Project	<b>IEEE 802.16 Broadband Wireless Access Working Group</b> < <a href="http://ieee802.org/16">http://ieee802.org/16</a> >	
Title	<b>Definition of the process for Adaptive Channel Selection</b>	
Date Submitted	<b>2006-02-28</b>	
Source(s)	Wu Xuyong, Zhao Quanbo, Pan Zhong,  Huawei Huawei Industrial Base, Bantian, Longgang, Shenzhen 518129 P.R.C	Voice: +86-755-28971677 Fax: +86-755-28975523  <a href="mailto:wuxuyong@huawei.com">wuxuyong@huawei.com</a>
Re:	80216h-06_005: Call for Comments and Contributions: IEEE 802.16 License-Exempt Task Group (2006-02-06)	
Abstract	In order to collect the information from all the influenced BS nearby, IBS need to scan all the channel and broadcast the contact information in all the candidate channel. After collect the necessary information, BS need to start negotiate with the neighbors when necessary. Updating the information during operation is still open and not the main purpose of this paper.

## Definition of the process for Adaptive Channel Selection Huawei Technologies Co., Ltd.

Figure h17—Initialization procedures — BS

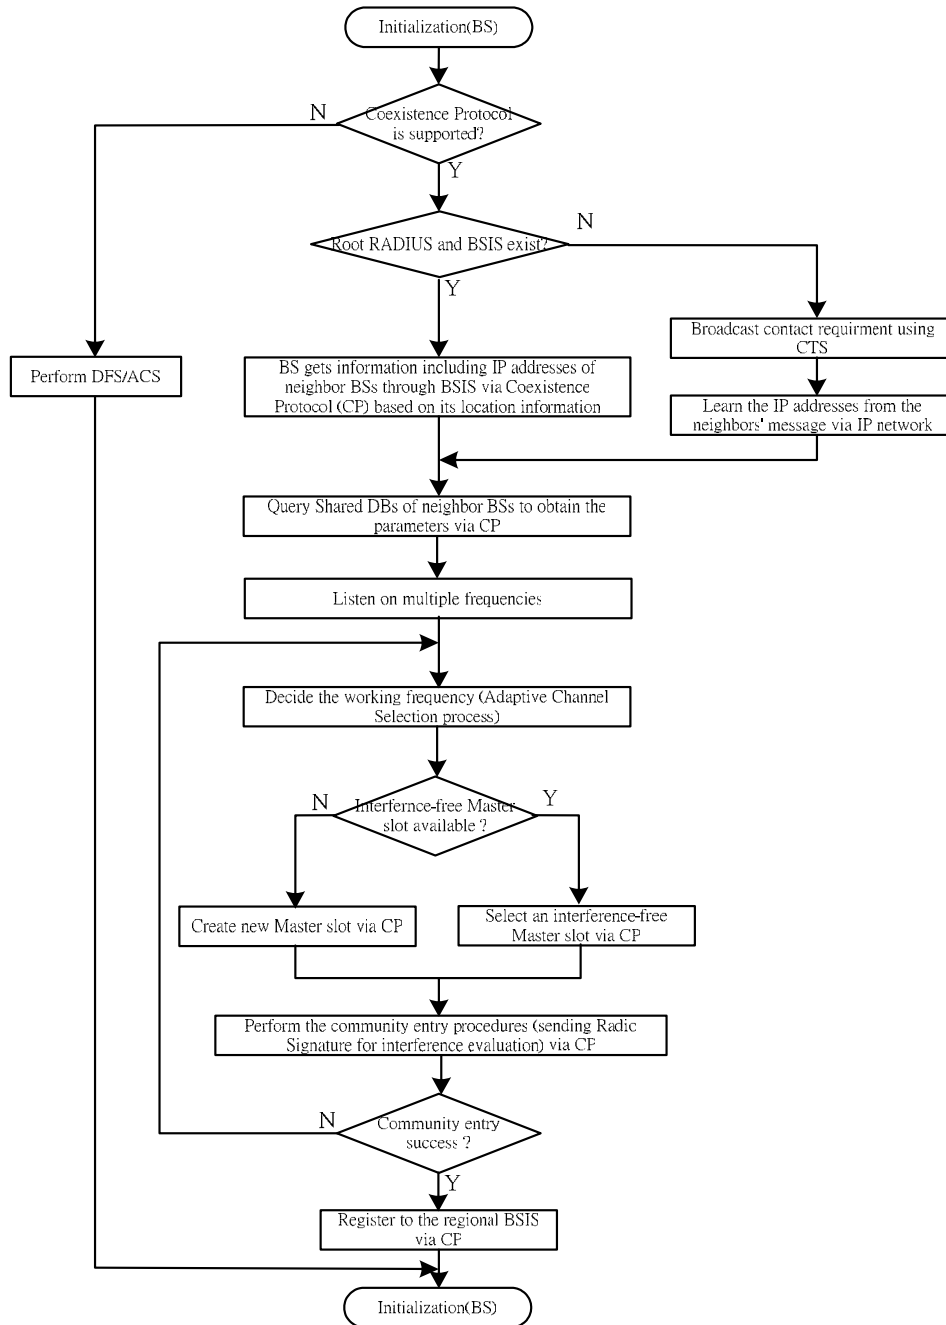
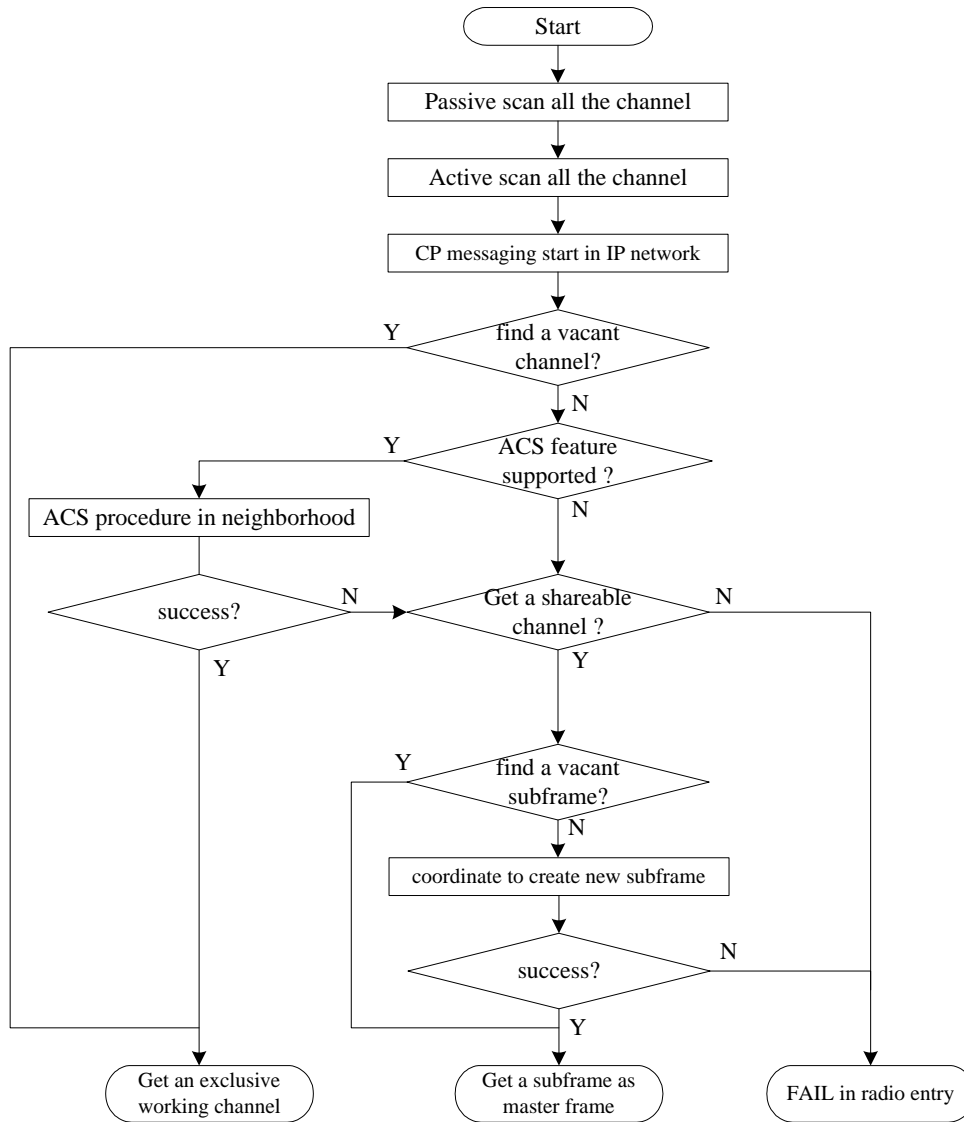
the following diagram figure h17 in 15.2.1.3 need to be change.

To clarify the description of initialization procedure, the resource allocation and CP messaging procedure should be defined separately.

*Change the Figure h17 in 15.2.1.3 as indicate:*

Figure h17—Initialization procedures — BS radio resource allocation
